Appendix C: Consultation (Notice & Summary)

Colborne Street Bridge, City of Kawartha Lakes

PIC Frequently Asked Questions, July 15, 2025

PUBLIC INFORMATION CENTRE (PIC) SUMMARY REPORT	
Purpose of PIC:	The purpose of the PIC was to present the detailed design, current stage and planned schedule of the proposed bridge and gather feedback from the General Public, Indigenous Nations, and other stakeholders.
Venue	
Date:	Tuesday, July 15, 2025
Time:	5:30pm to 7:30pm - 30-minute presentation started at 6pm
Location:	Kawartha Lakes City Hall, Victoria Room 26 Francis St, Lindsay, ON K9V 5R8
Format:	The PIC consisted of an in-person drop-in event. A formal presentation was held at 6:00 PM. Supporting materials were also posted on the project website. Presentation: https://www.kawarthalakes.ca/en/business-growth/resources/Engineering/Colborne-Bridge--PIC--Presentation-July-15-2025.pdf Display Boards: https://www.kawarthalakes.ca/en/business-growth/resources/Engineering/Colborne-St-Bridge-PIC-Display-Boards.pdf
Notification	
News Release	<ul style="list-style-type: none"> PIC Notice published as a news release on June 23, 2025 at https://www.kawarthalakes.ca/en/news/notice-of-public-infor

A+ Proposed Single Span Arch Bridge Alternative

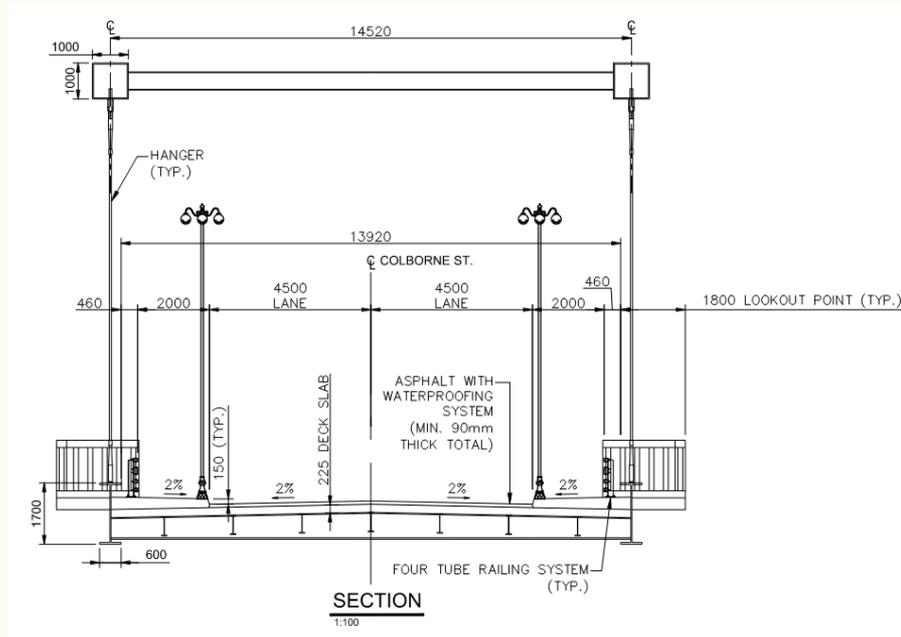
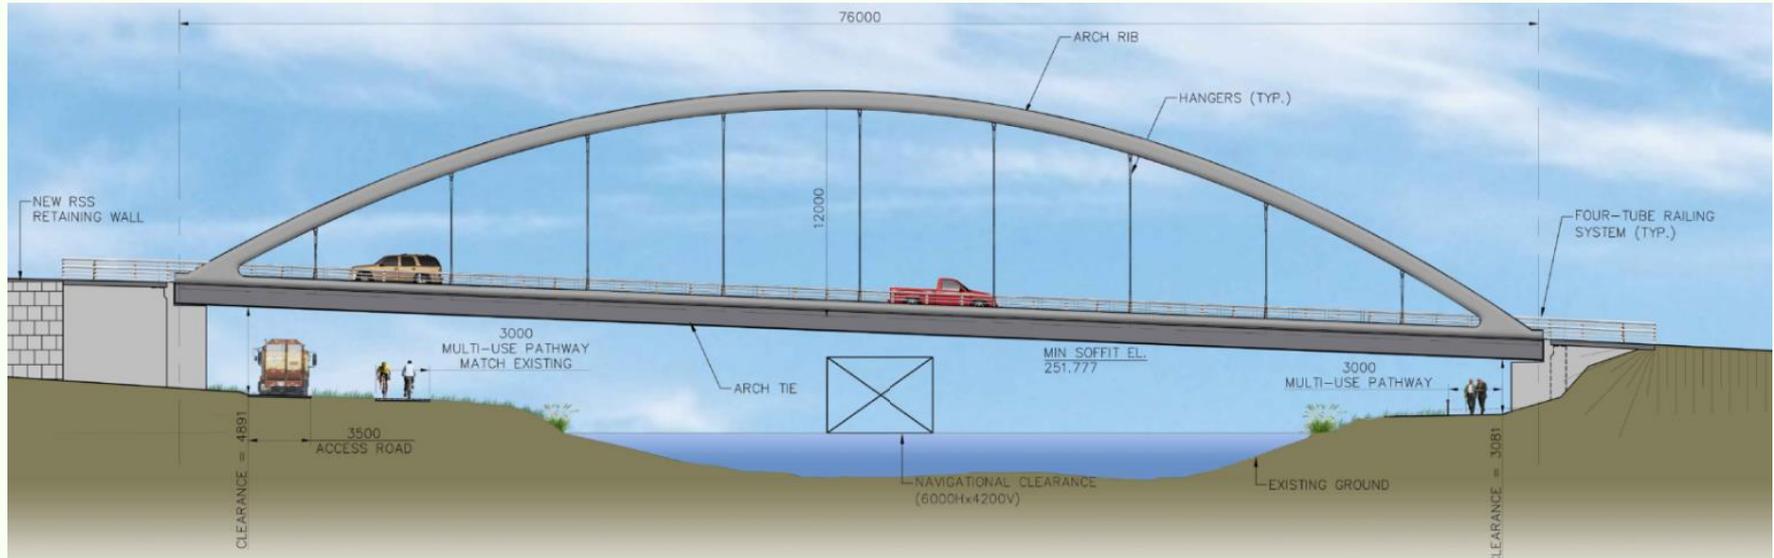
- I really like the single span arch bridge design and I support that concept. The PIC display boards show a blue coloured bridge, while slide 10 of the PPT shows a grey bridge. The blue colour looks really good, as demonstrated in the example photos, and I support a blue coloured bridge.
